Subject of this Document: Turkey Point Nuclear Power Plant
Safety Evaluation Report Review

Subject: Fire Protection in Operating Nuclear Power Stations - Turkey Point
Nuclear Power Plant Safety Evaluation Report Review

Subject: Fire Protection in Turkey Point Nuclear Power Plant - Units 3 & 4,
Request for Additional Information

FIRE FIGHTING STRATEGY #7

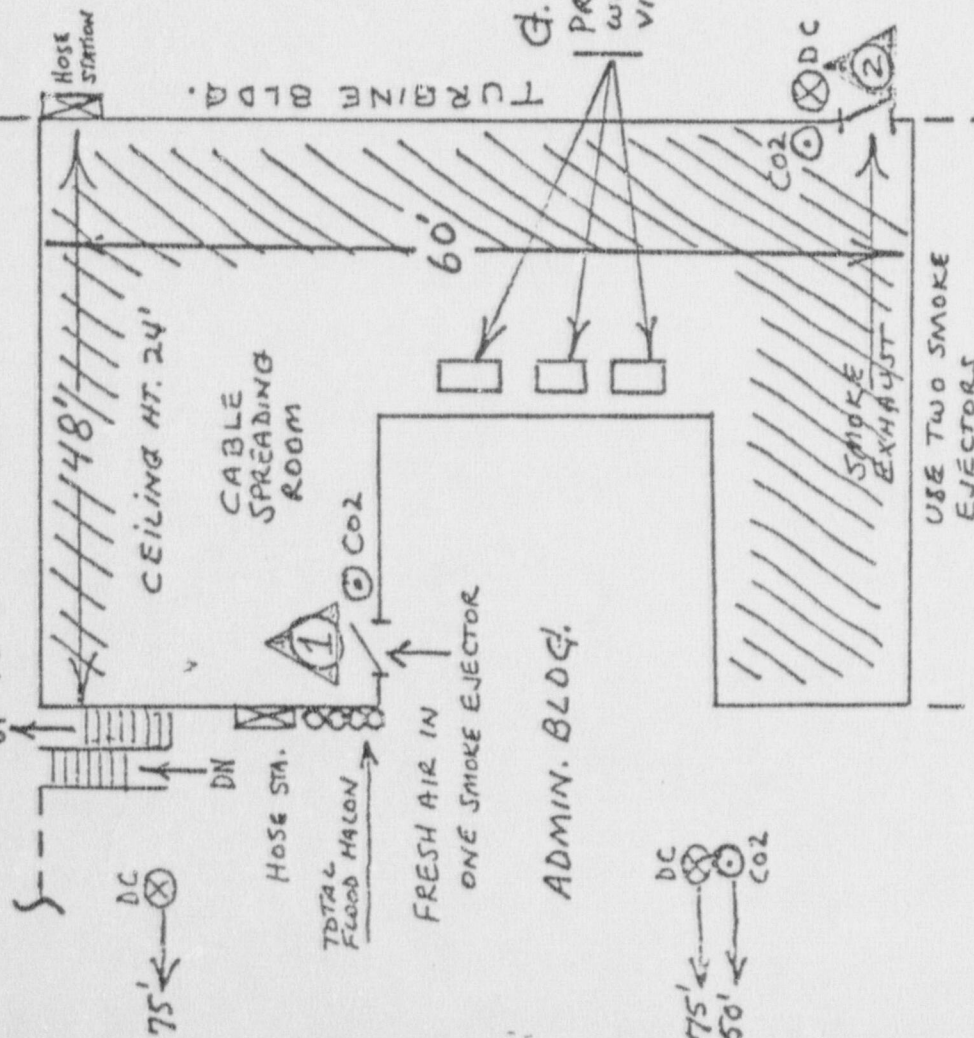
A minimum of three portable smoke ejectors with at least 17,500 CFM capacity...

An examination of specific locations at Turkey Point showed that there were areas where the BNL consultant determined that three fans were required due to the large size of these areas. An example of this is the 4160 volt switchgear rooms which contain approximately 14,000cu. feet each, and the long hall in the auxiliary building which contains approximately 21,000cu. feet. These areas and other large areas may require one fan blowing fresh air in and two fans exhausting smoke.

A typical large room pre-fire plan is attached showing the recommended fan arrangement, Ref. Figure 1.
